DESIGN REVIEW RECOMMENDATION

SDCI #3040275-LU
6102 14th Ave NW
Seattle, WA 98107

Applicant:
Cone Architecture
1319 N 49th Street
Seattle, WA 98103
Contact: Emily Terzic

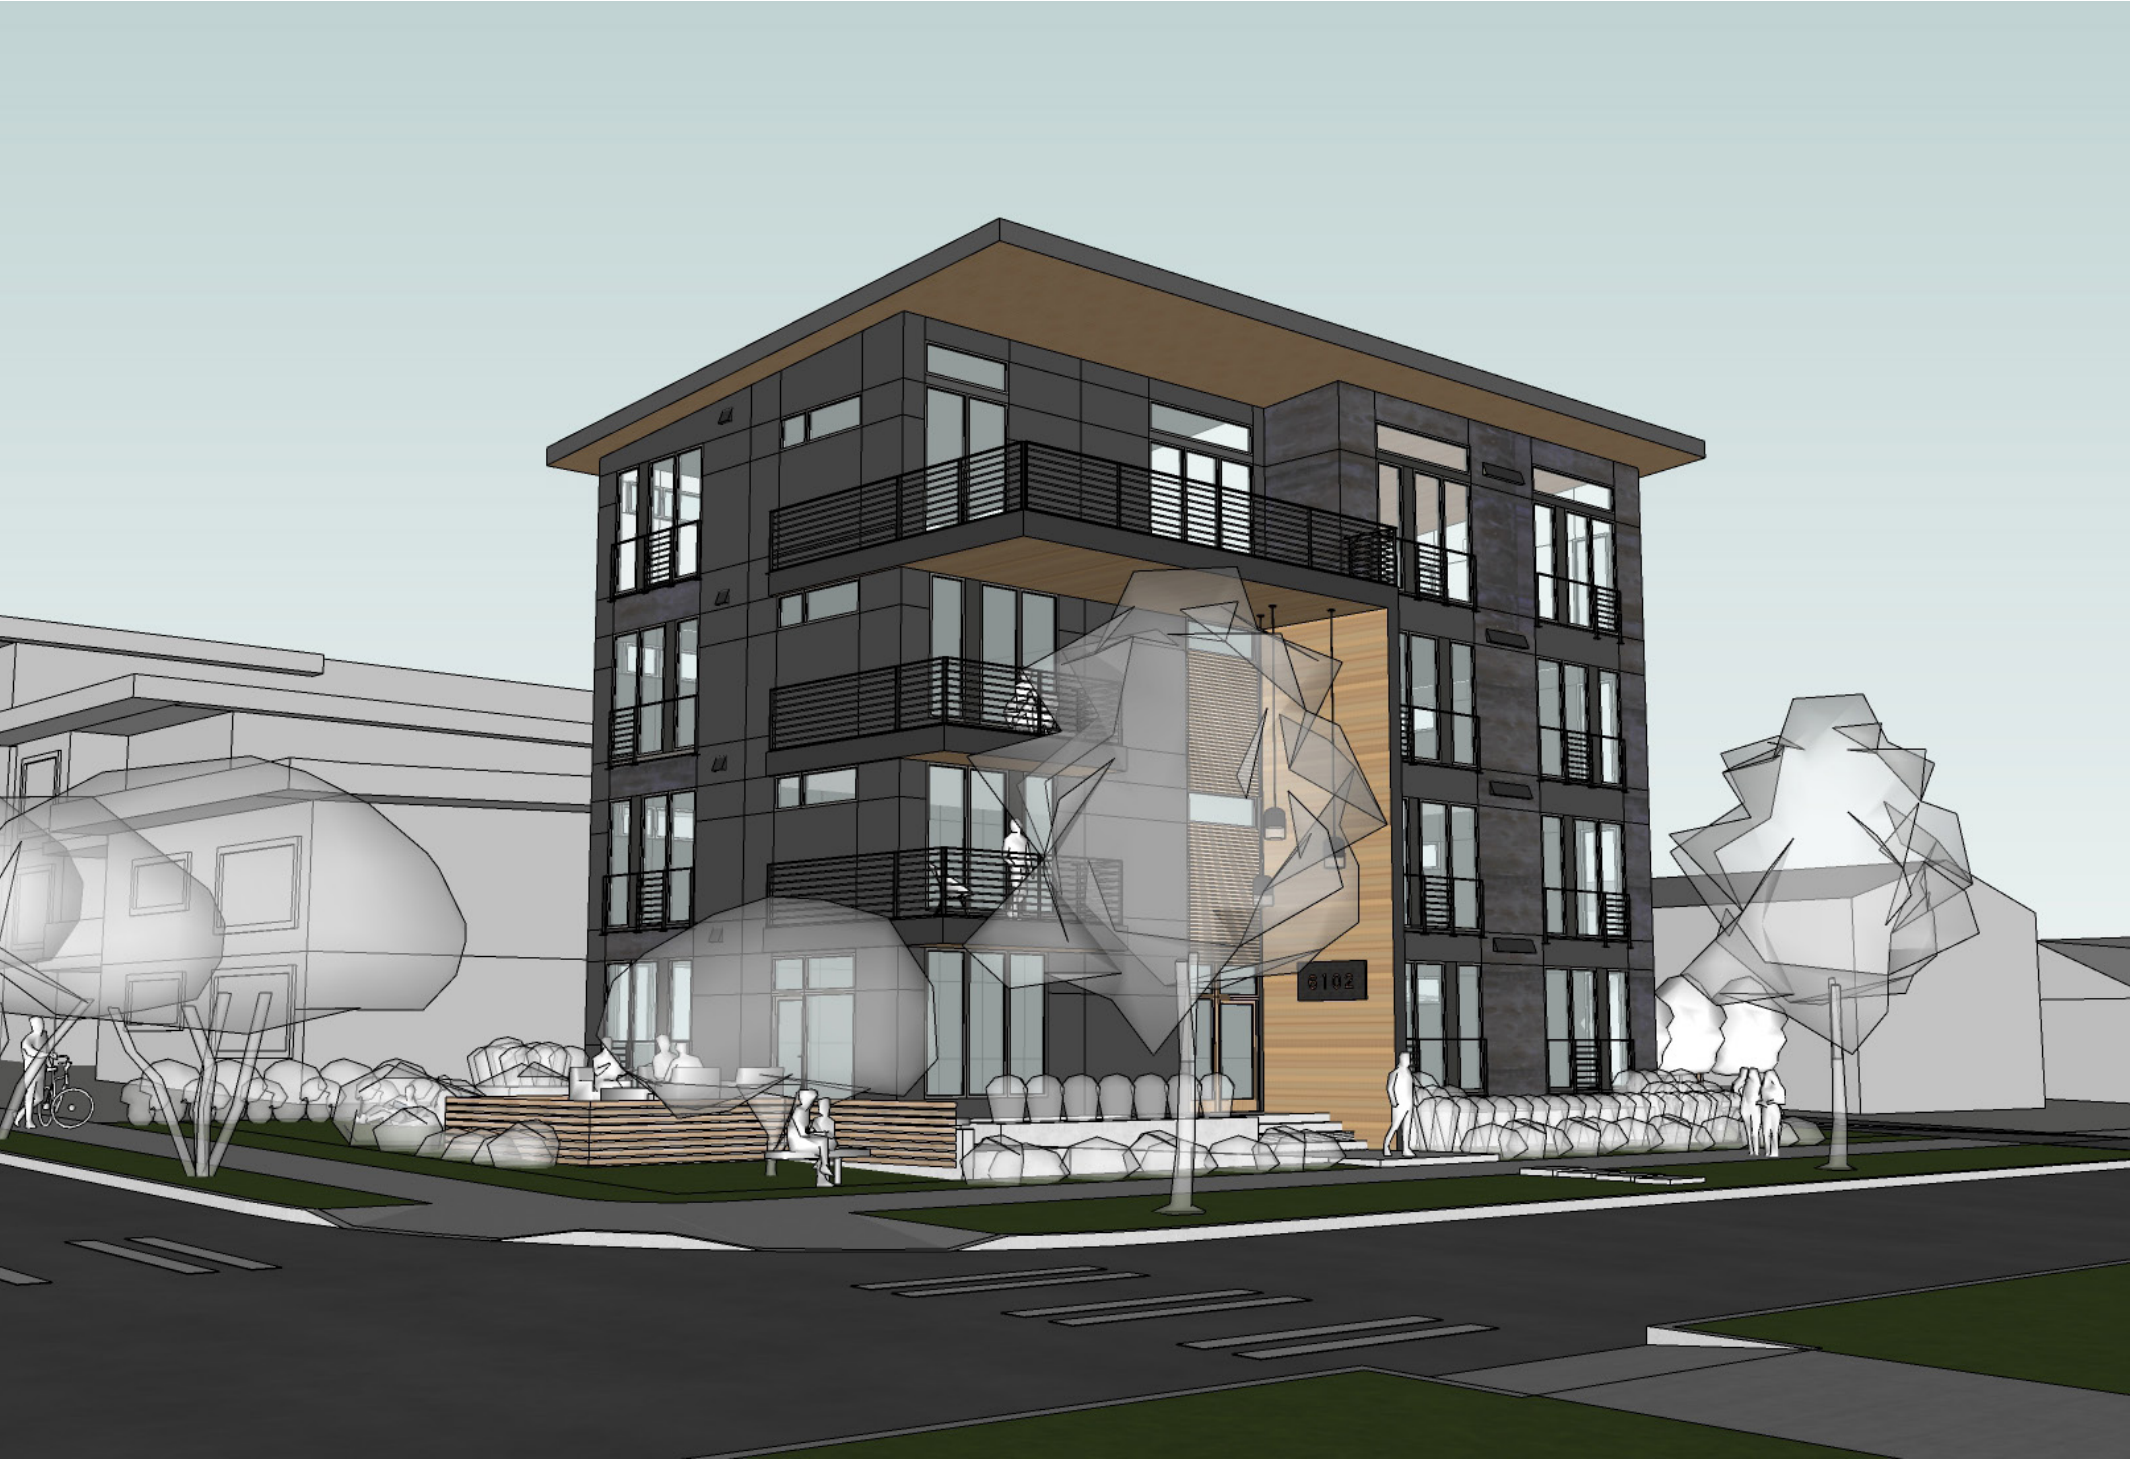
The Board supported the locations of the primary residential entry and lobby at the southwest corner of the building in Option 3, stating that this location provides a high level of entry legibility and is appropriate for the corner site. The Board added that the south-facing door placement will help to activate the paved amenity area along the NW 61st Street frontage.

The residential entry has been maintained at the southwest corner of the building with access off of NW 61st St. This area has been further refined and connected to an amenity space at the street corner. The entry itself is highlighted with the use of a fin wall that drops from the fourth level deck, accentuating with the warmth of cedar and the presence of an architectural pendant light.

VIEW FROM THE CORNER OF 14TH AVE NW AND NW 61ST ST

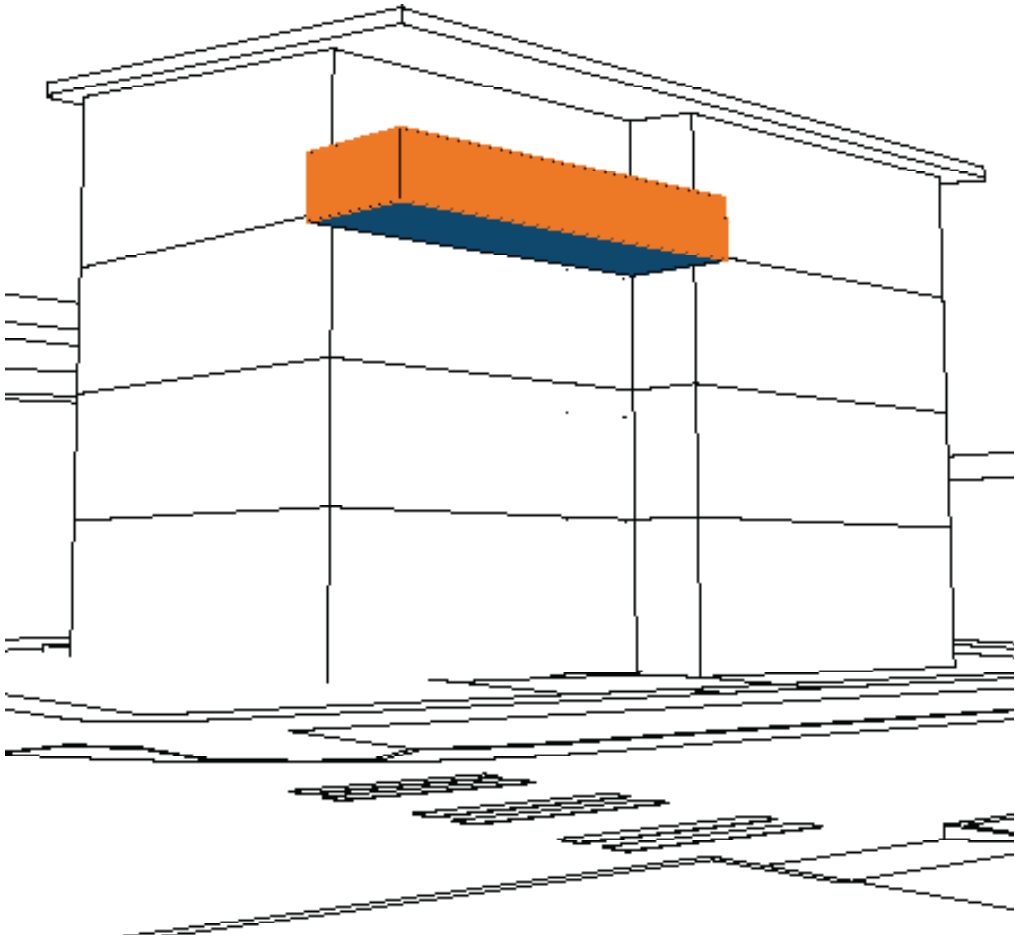
The Board supported the simple massing form and shed roof design in Option 3, which are compatible with the forms of surrounding multi-family buildings. The Board added that the shed roof provides an opportunity for solar gain or solar energy.

The single shed roof has been maintained from the EDG concepts of Option 3. The direction of the shed roof has been re-oriented to slope down to the north so drainage can be oriented towards the north property line where a biplanter has been located to both provide privacy from the north neighbor but also grade reconciliation. Sloping the roof down to the north also reduces the overall height of the building at the shared property line.

REC MASSING - INTEGRATED DECK AND ENTRY DESIGN

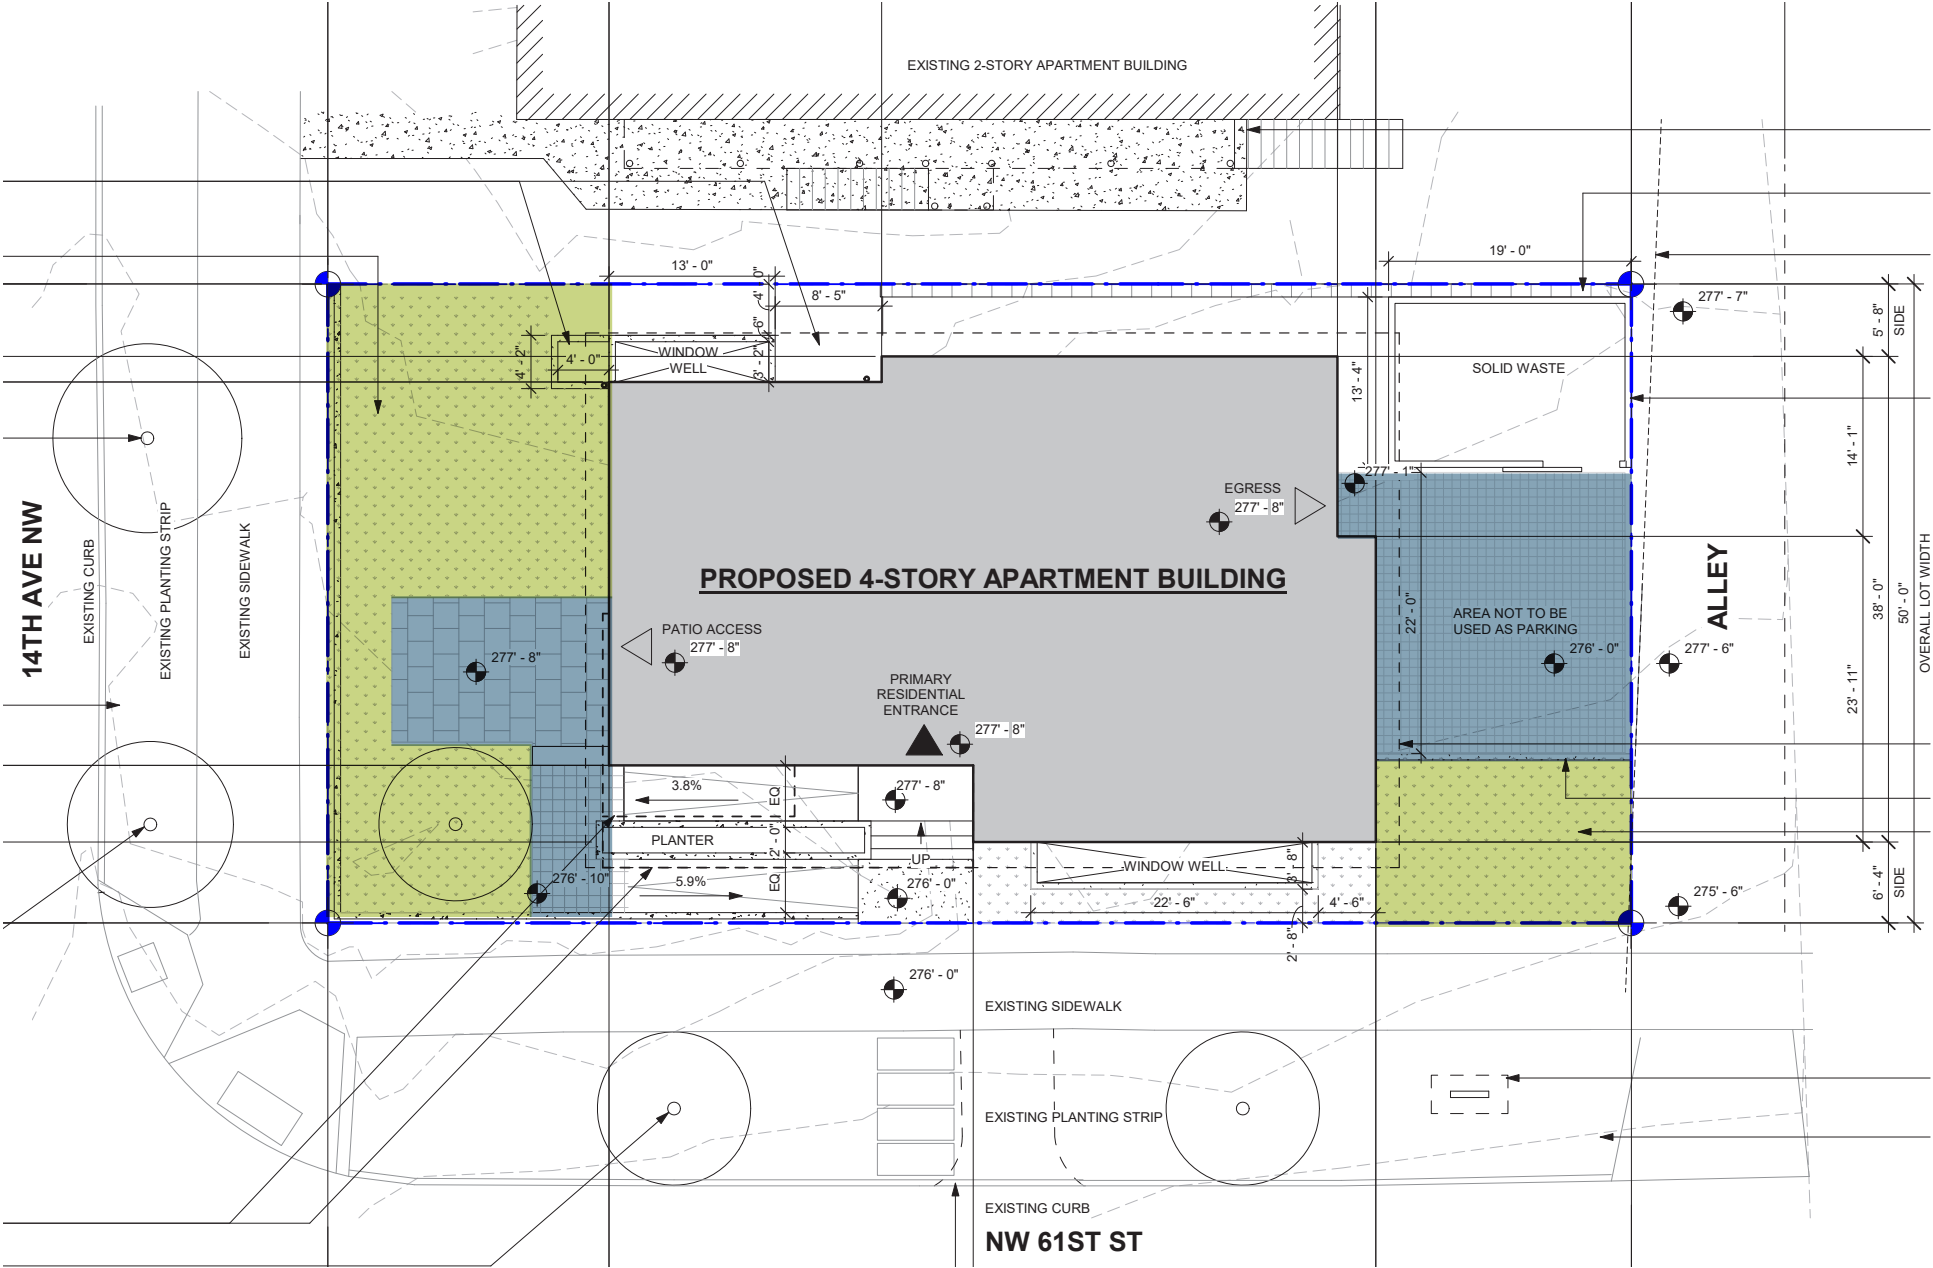
The Board urged additional integration of the third-floor balcony on the south façade into the design concept of Option 3, stating that its current expression appears to be an awkward attachment to the simple massing form. The Board encouraged the development of a consistent strategy for integrating secondary architectural elements, such as balconies, into the design concept (DC2-B-1. Façade Composition, DC2-C. Secondary Architectural Features).

The proposed fourth floor balcony on the south façade has been further integrated into the overall design concept through the addition of decks on level 2 and 3, creating a stacked condition that fits into the existing context of the neighborhood. Level two and three decks are pulled back to highlight the three story residential entry, with the fourth level decks cedar soffit wrapping down for a pedestrian scaled material at the entry. This typology of repeating decks is present in many neighboring buildings, which can be further seen through the diagram on page 17.

Juliet balconies have been added to the the west and south facades and private outdoor space is being provided at the western amenity space to support outdoor access for all.

PRIVACY DIAGRAMS

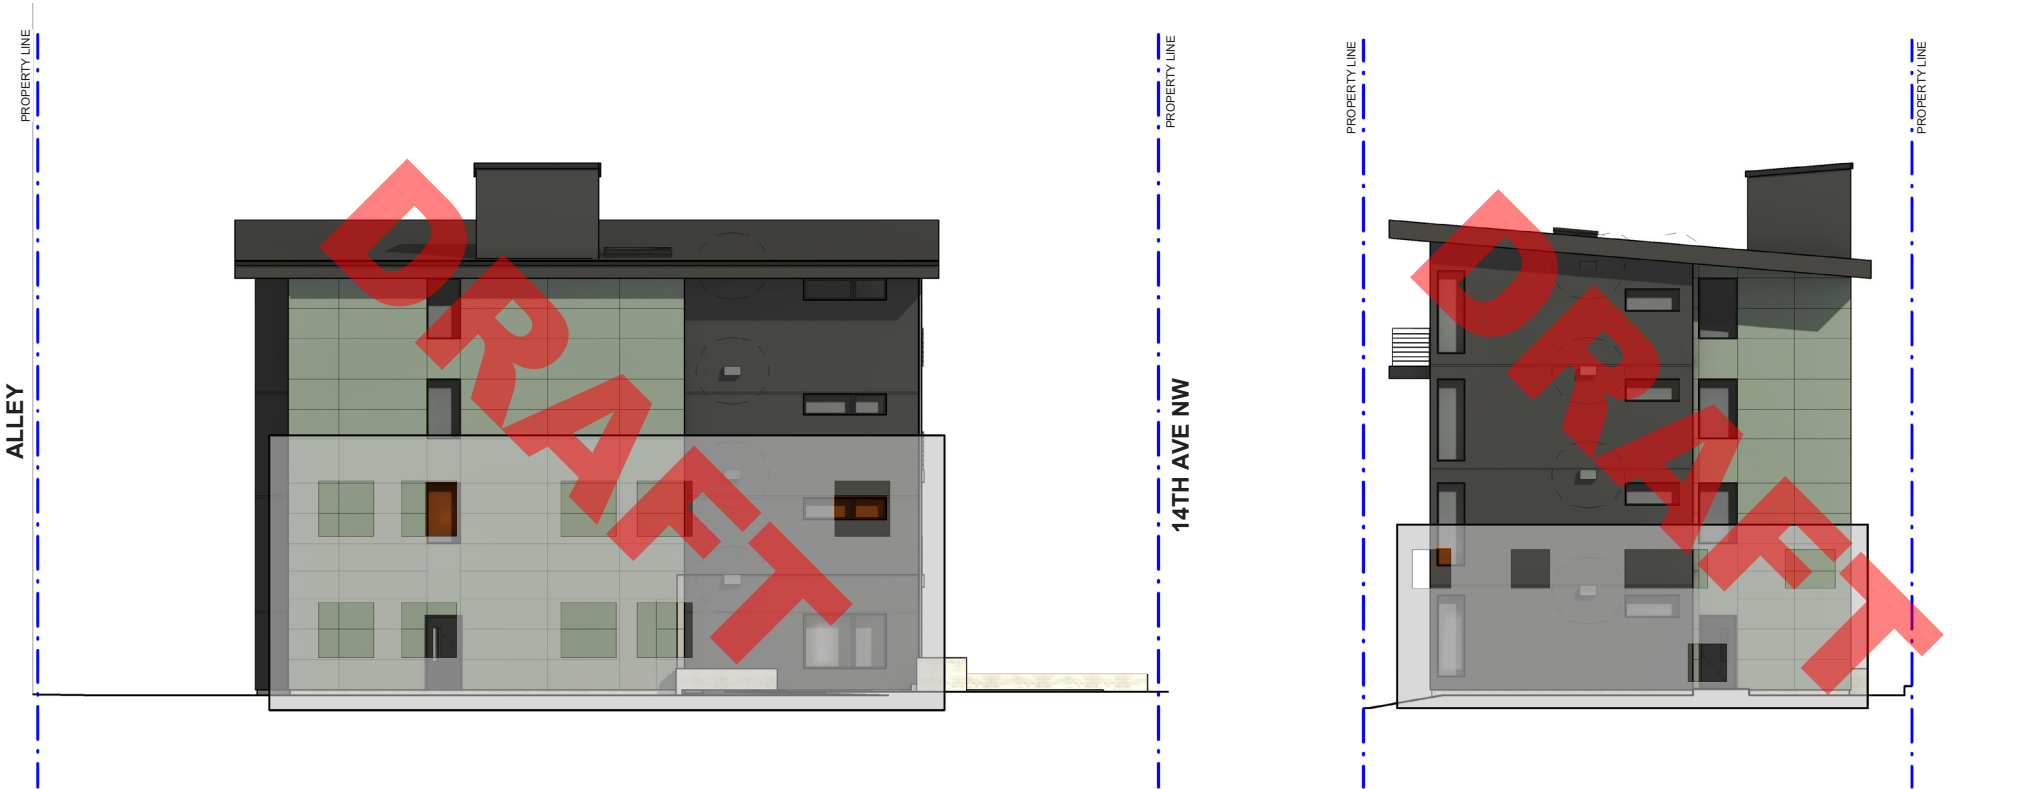
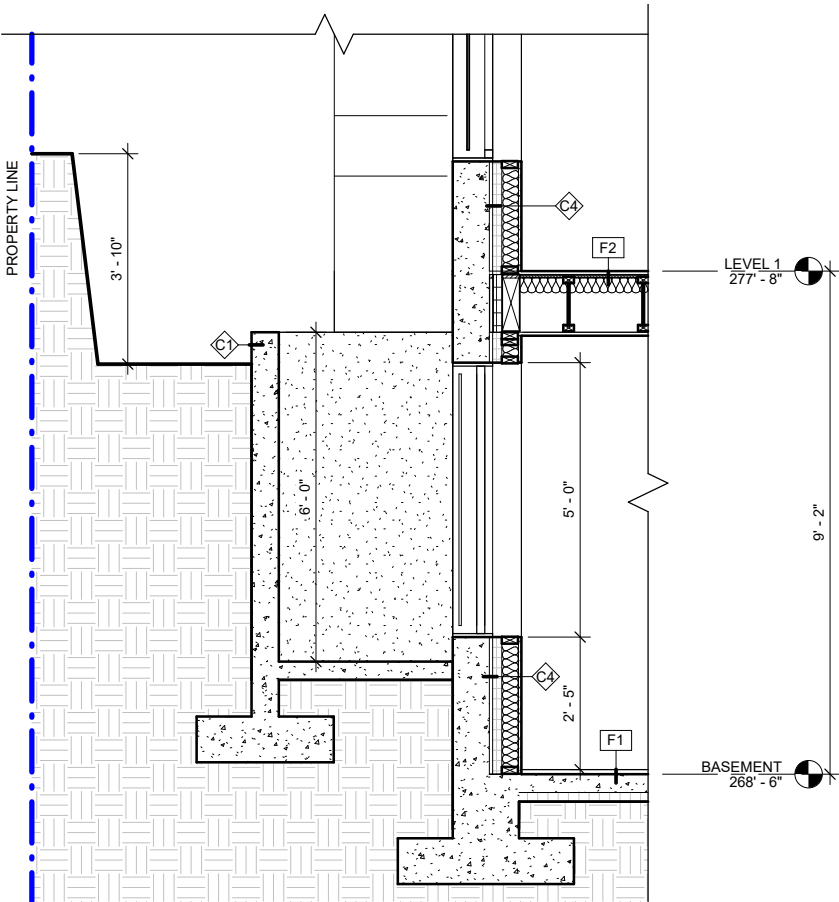
The Board requested a site section drawing and a window privacy diagram at the Recommendation phase of review to show how the proposed building mass will relate to adjacent development in the Neighborhood Residential 3 zone to the east of the site and maintain privacy to adjacent residents (CS2-D-3. Zone Transitions, CS2-D-5 Respect for Adjacent Sites, PL3-B-1. Security and Privacy).

Please reference the provided diagrams to see the minimal overlap in glazing between the proposed design and adjacent buildings.

The site elevation along NW 61st St shows the additional 10'-0" provided at the zone transition to allow for greater separation between the single family home and the proposed design. The eastern amenity space acts as a buffer at this transition while providing double the required setback.
